2007/2008 PROPOSED CHANGES TO THE INTERNATIONAL BUILDING CODE — FIRE SAFETY

FIRE SAFETY CODE COMMITTEE

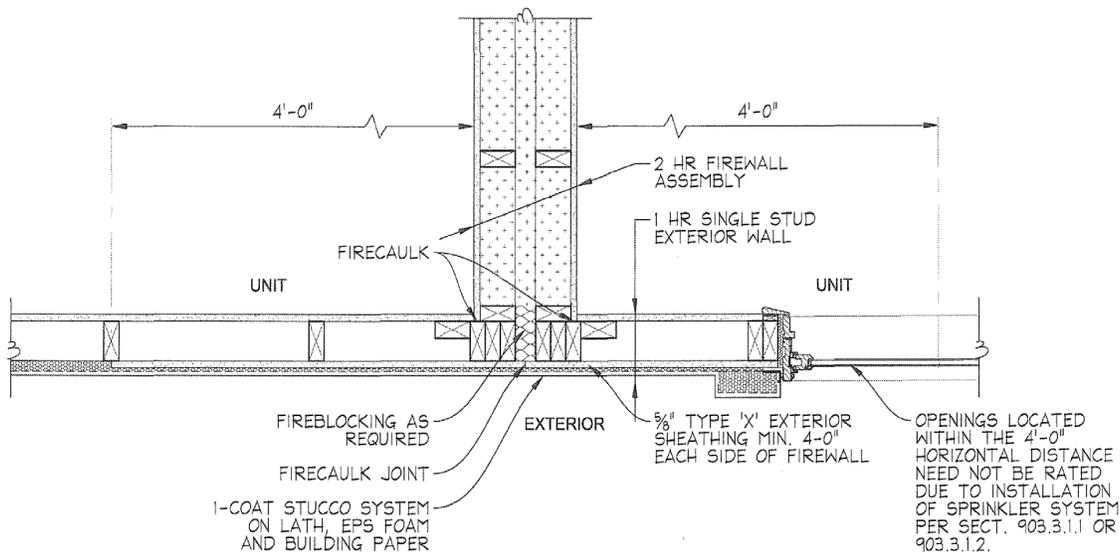
Reason: Exception 3 needs to be clarified. When using sprinkling systems on each side of an interior Fire Wall, Exception 3 does not explain how much noncombustible exterior sheathing is required on each side of the Fire Wall. With a sprinkling system in place per Section 903.1.1 or 903.1.2 there is no need to extend the noncombustible exterior sheathing the entire length of a building, and there is no need to protect openings. Without the additional language, Exception 3 is ambiguous. A detail of the proposed change is attached.

Cost Impact: The code change will not increase the cost of construction since the change would allow the application of four feet of noncombustible sheathing on each side of a Fire Wall, instead of the application of noncombustible sheathing the entire length of a building.

705.5 Horizontal continuity. Fire walls shall be continuous from exterior wall to exterior wall and shall extend at least 18 inches (457 mm) beyond the exterior surface of exterior walls.
